# Development Engineering Formal Referral Response

<b>Referral Officer:</b>	Mark Pisani
<b>Officer:</b>	Corey Wooldridge
<b>Council Reference:</b>	PLN23/0661
<b>Referral Number:</b>	IREF23/01997
<b>Address:</b>	9 Arthur Street, Fairfield
<b>Proposal:</b>	Construction of two double storey dwellings on a lot
<b>Comments Sought:</b>	Access arrangements; internal layout
<b>Disclaimer:</b>	Council's Development Engineering unit, provides the following advice based on information provided in the referral request memo referenced above.

# Open Space Services Formal Referral Response

# Urban Design Formal Referral Response

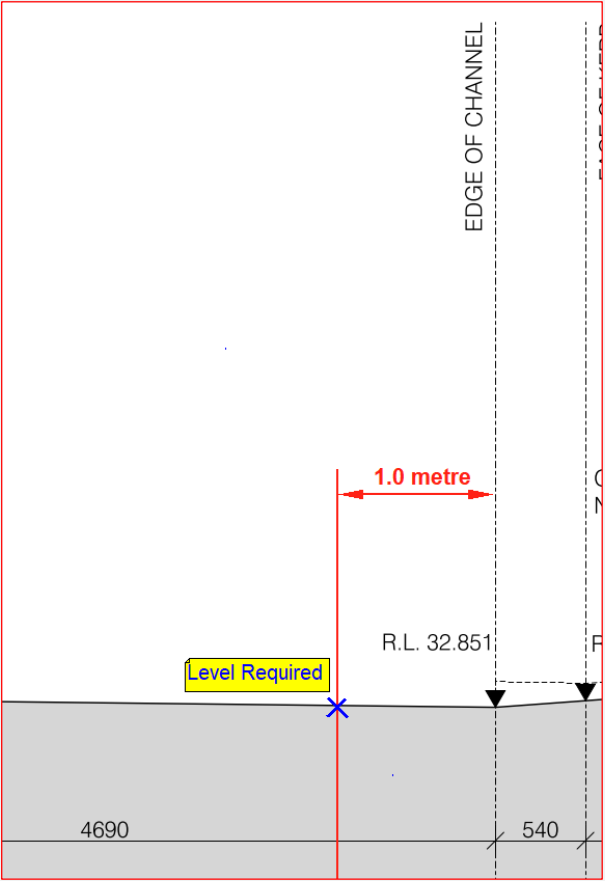
Ramp Grades and Changes of Grade	The ramp grades and changes of grade satisfy <i>Table 3 Ramp Gradients</i> of Clause 52.06-9.
<b>Other Items</b>	
Vehicle Crossing – Unit 1	There is no objection to the continual use of the existing vehicle crossing to service unit 1.
Vehicle Crossing – Unit 2	The cross sectional drawing of the vehicle crossing must apply along the centre line of the vehicle crossing, as per diagram below:

The cross sectional drawing does not appear to accurately represent the road profile of Arthur Street. The invert (the low point) has been incorrectly depicted at the edge of the channel. The invert of the east kerb of Arthur Street is located at the face of the kerb. The footpath and road pavement levels must be re-taken/revise.

The road pavement level 1.0 metre from the edge of the kerb must be provided to complete the cross sectional drawing.

The cross sectional drawing is to be resubmitted for assessment.

Item	Engineering Requirement	Action for Applicant
1	Dimension each garage doorway	Update the drawings.
2	Revise the vehicle crossing cross sectional drawing along the centreline of the proposed vehicle crossing. The road pavement level 1.0 metre from the edge of the channel must be provided. Road pavement, kerb and footpath levels must be actual levels along centreline of the crossing.	Revise and resubmit the vehicle crossing cross sectional drawing to apply along the centreline of the vehicle crossing and with revised levels.
